UNITED STATES PATENT AND TRADEMARK OFFICE

APPLICATION NO.	FILING DATE	FIRST NAMED INVENTOR	ATTORNEY DOCKET NO.	CONFIRMATION NO.
10/705,386	11/10/2003	Pierre Liu	2011137	4320

Office Action Summary

DETAILED ACTION

FIG. 5E

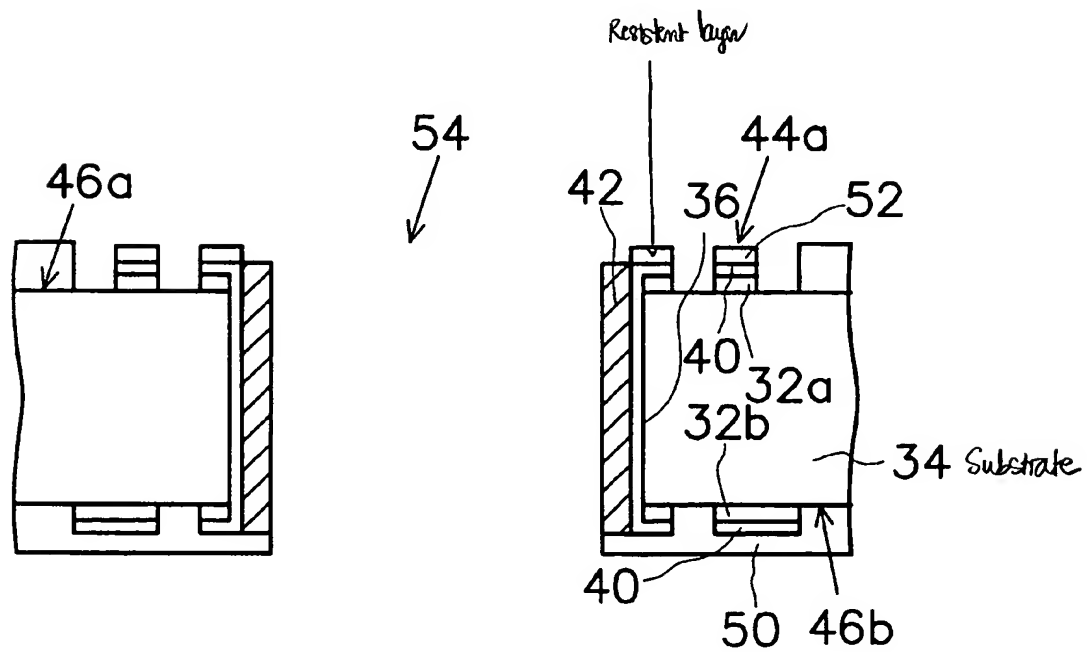
forming with a plurality of connected points (44a), the length of the wiring regions are smaller than long slot (54) of the substrate (34); a layer (52 shown in Figs. 5E) is characterizes as a resistant layer (see attached Figs. 5E, 7) coated on the lower surface of the substrate (34), and located between the long slot (54) and wiring region; a glue layer 58 being coated on the upper surface of the substrate and being located at the periphery of the long slot (54); an integrated circuit (56) having a first surface (64) forming with a plurality of bonding pads (60) and a second surface, the first surface (64) being adhered to the glue layer (58), then the bonding pads (60) being exposed from the long slot (54) of the substrate (34); a plurality of wires (62), each of which is arranged within the long slot (54) of the substrate and is electrically connected the bonding pad (60) of the integrated circuit (56) to the connected point (44a) of the substrate; and a first compound layer (68) being filled within the long slot (54) of the substrate for protecting the each wire.

resistant layer coated on the lower surface of the substrate between the long slot and wires region, the examiner respectfully disagrees with the remark. It is clear that Chang teaches a resistant layer (52) coated on the lower surface of the substrate (34) and between the long slot (54) and wiring regions.
